Application/Control Number: 10/789,268

Art Unit: 3725

Fig. 3  
(PRIOR ART)

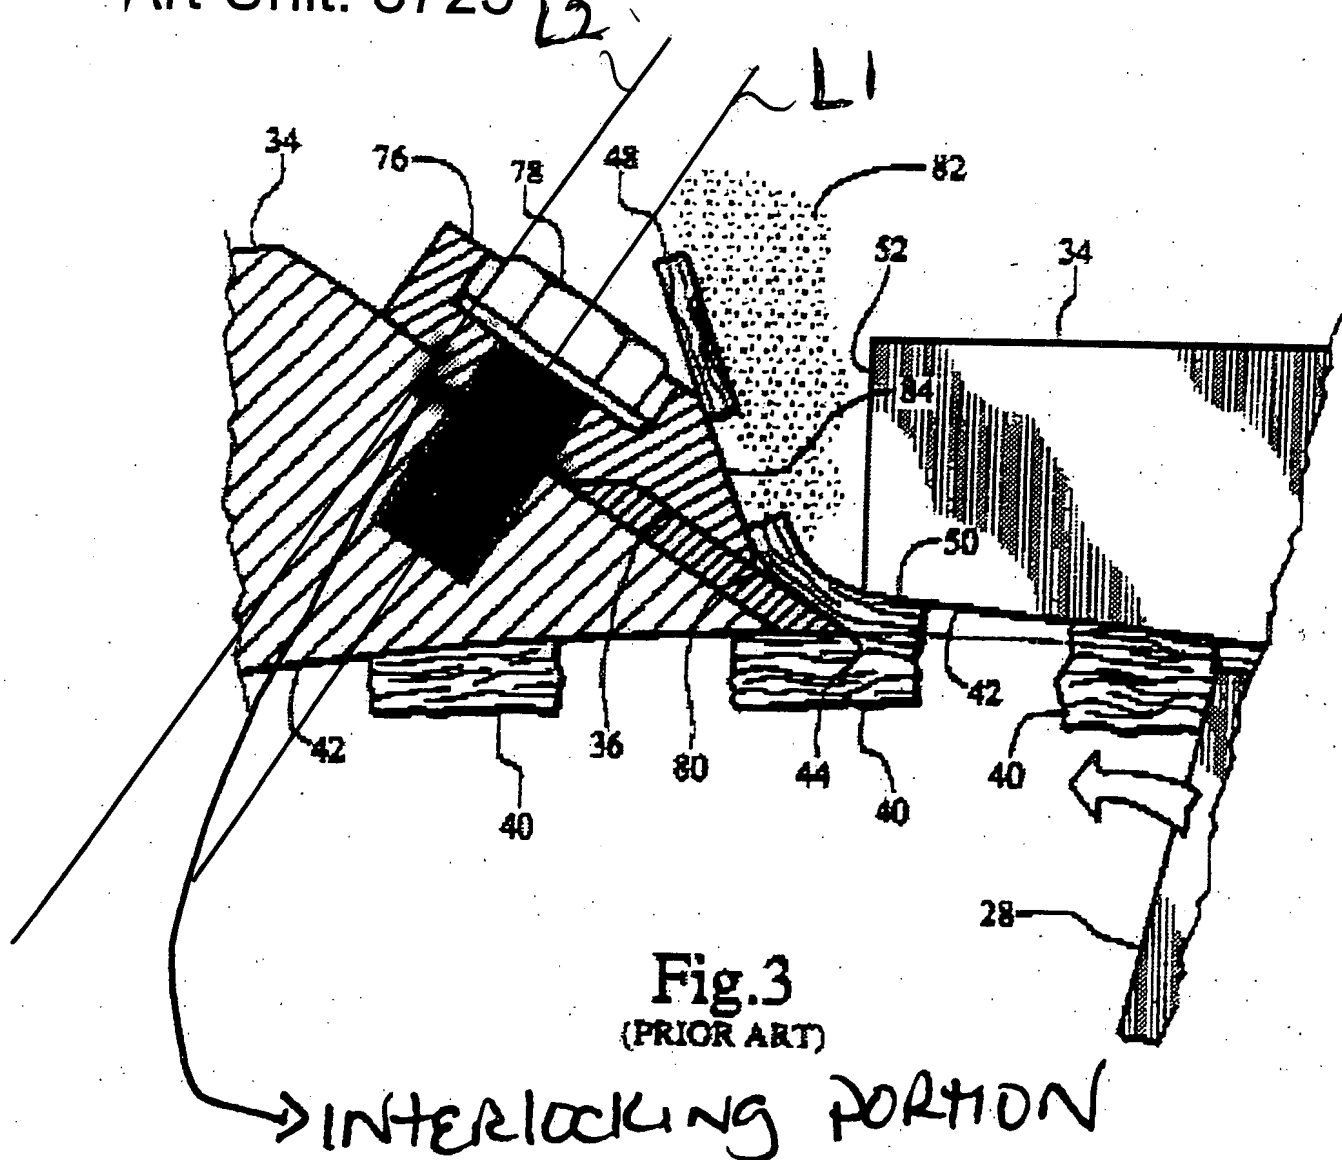
and base include cooperatively interlocking portions for movement of said base, relative to said wearshoe and perpendicular to the axis of said bolt, said interlocking portions define an angle  $\phi$  with respect to said first direction of movement. Applicant's attention is directed to the below marked

Further, in col. 5, lines 3-5 of Bielagus, member 65 and counter knife 68 via member 78 to clamp the k examiner takes the position that the interlocking po define an angle of the specified range noted above.

→ INTERLOCKING PORTION
